Subject: Fwd: Final version of email to WS

Dear Mr Simcock

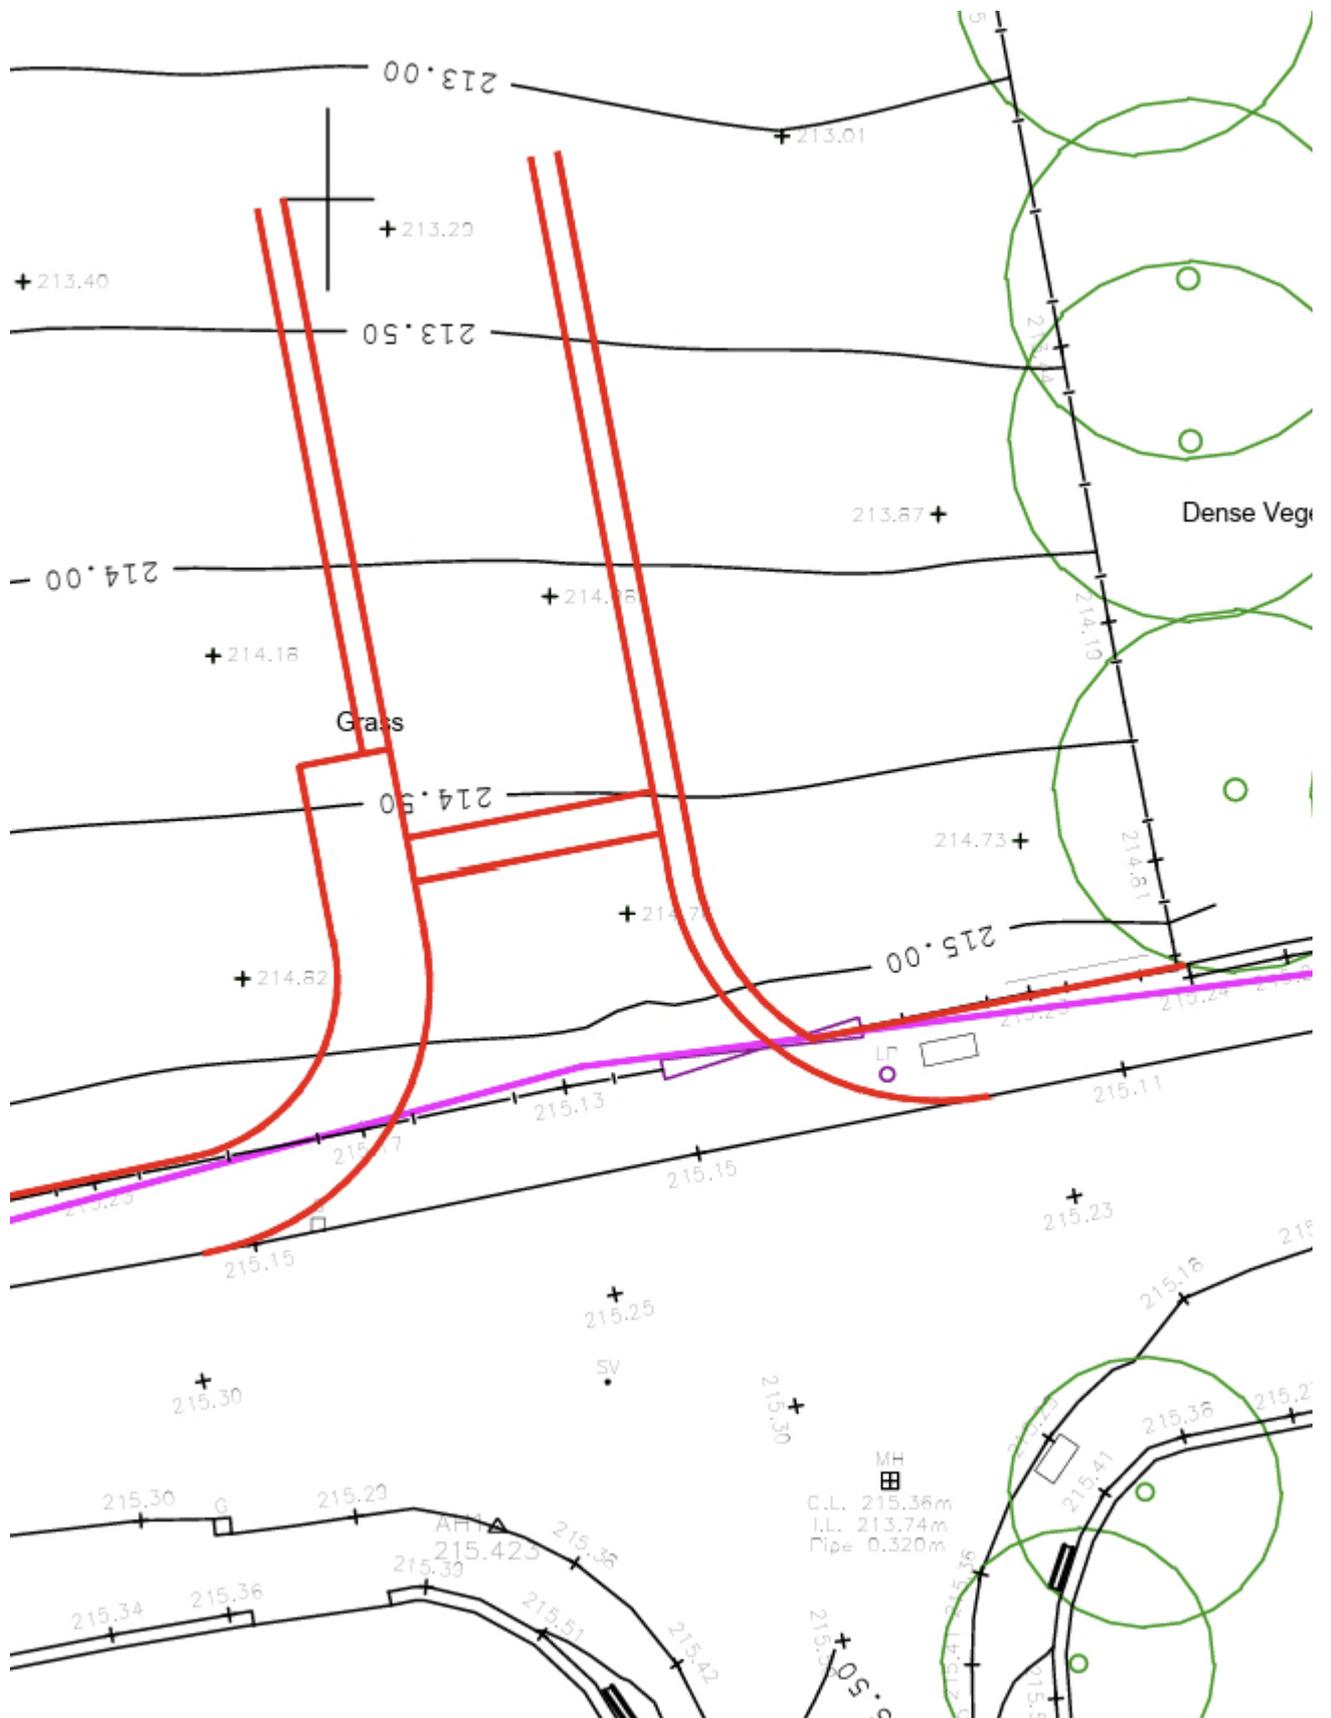
1. Although the visibility splay is now imposed on the topographical survey my comments upon the speed survey data (as set out in my previous letters) still applies. In addition, plan "003" still does not show any road widening on Denby Lane (in the direction of the Ben Booth Lane junction) that is likely to be necessary to permit large vehicles to turn both right into the proposed development from Denby Lane and left out of it to Denby Lane, see extract below.

Again, this point was raised in my last detailed letter to you. If road widening is required, which is my belief from the swept path diagrams previously submitted by Sandersons, then this may impact on the nearside kerb line of Denby Lane and hence on the delivery of the sight line looking left from the proposed junction. Notwithstanding any grant of planning permission, it is likely that the Council will examine these matters further at the stage of estate road adoption and therefore it is appropriate that they are considered now.
